DAEC
Iowa Electric Light and Power Company
Technical Specifications

By letter dated December 30, 1991, Iowa Electric Light and Power Company requests revision to the Duane Arnold Energy Center (DAEC) Technical Specifications (TS). The proposed revision will combine the Recirculation Pump Limiting Condition for Operation (LCO) and Surveillance Requirements of Sections 3.3.E/4.3.E and 3.6.F/4.6.F into one Section (3.3.F/4.3.F), modify Figure 3.3-1 for clarity, add Single Loop Operation (SLO) thermal limit adjustments referenced in the Core Operating Limits Report (COLR) to Section 3.3.F and remove them from Section 3.12, and make minor editorial changes and corrections.

Thermal Power vs Core Flow Limits
for Thermal Hydraulic Stability
Surveillance
Figure 3.3-1

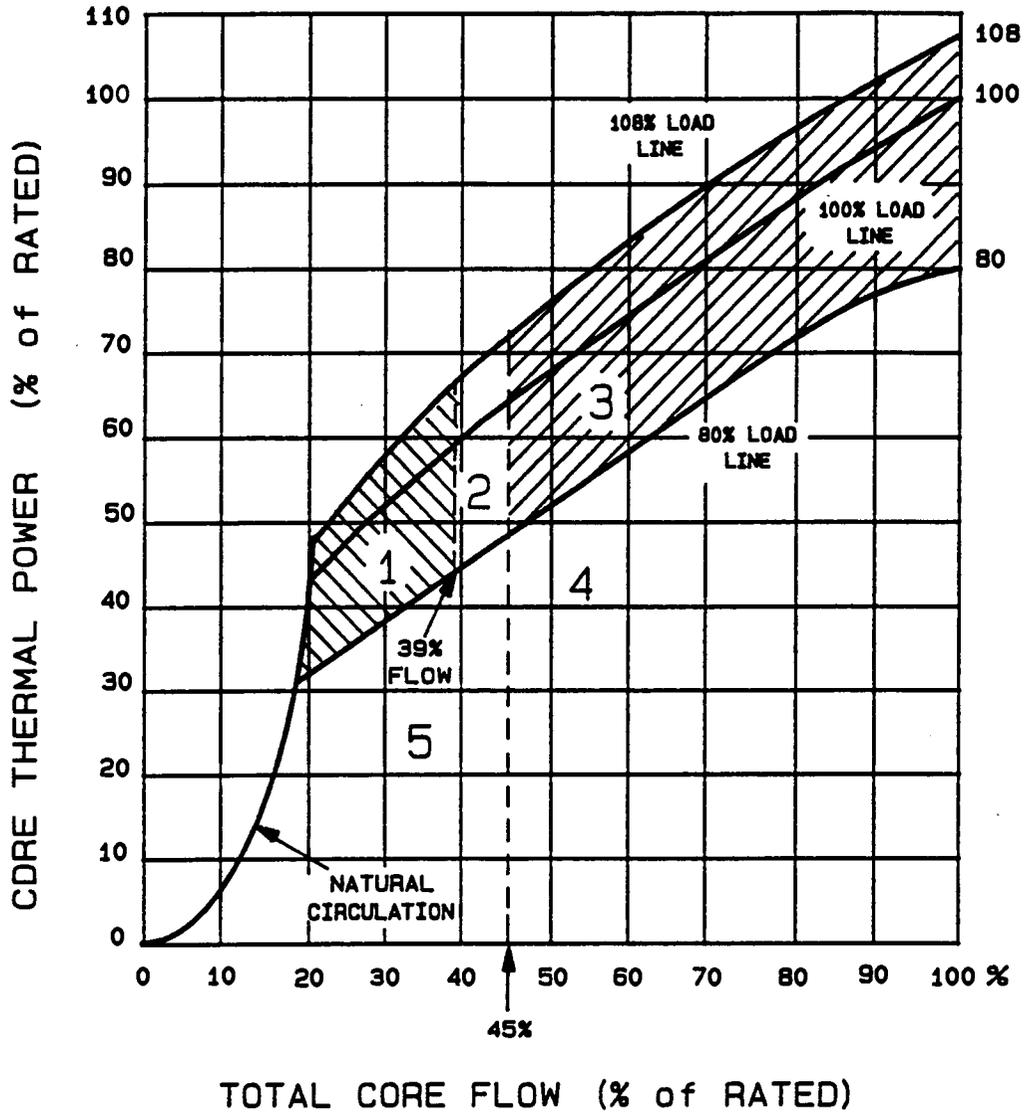
With two recirculation pumps in operation in Regions 1 or 2 of Figure 3.3-1, operation is permitted provided that:

a. With two recirculation pumps in operation in Regions 1 or 2 of Figure 3.3-1, establish baseline APRM and LPRM* neutron flux noise levels within 2 hours, provided that baseline values have not been previously established since the last core refueling.

b. While in Regions 1 or 2 of Figure 3.3-1, determine APRM and LPRM* neutron flux noise levels at the following intervals:

- a. Jet Pump baseline data for SLO shall be updated as soon as practical after entering SLO per Specification 4.6.E.4.
- b. Prior to SLO operation in Regions 2 or 3 of Figure 3.3-1, establish baseline APRM and LPRM* neutron flux noise levels, provided that baseline values have not been previously established since the last core refueling. Baseline values shall be established during SLO and in the Regions below the 80% load line (Regions 4 or 5).
- c. While in Regions 2 or 3 of Figure 3.3-1, determine APRM and LPRM* neutron flux noise levels at the following intervals:
 - (i) at least once per 8 hours,
and
 - (ii) within 30 minutes after the completion of a power increase of \geq 5% of rated core thermal power.

APRM and/or LPRM oscillations in excess of those specified in section 3.3.F could be an indication that a condition of thermal hydraulic instability exists and that appropriate remedial action should be taken. Instability can occur in two loop or single loop operation. Therefore, instability monitoring is required in certain regions of Figure 3.3-1.

Above 45% of rated core flow in SLO there is the potential to set up high flow-induced noise in the core. Thus, surveillance of core plate AP noise is required in this region of Figure 3.3-1 to alert the operators to take appropriate remedial action if such a condition exists.

- Region 1: Two Loop Surv. Region, SLO Prohibited Region
- requires APRM/LPRM noise monitoring
- Region 2: Two Loop & SLO Surv. Region
- requires APRM/LPRM noise monitoring
- Region 3: SLO Surv. Region
- requires APRM/LPRM & Core Plate D/P noise monitoring
- Region 4: Extended SLO Surv. Region
- requires Core Plate D/P noise monitoring
- Region 5: Unrestricted Two Loop & SLO Region
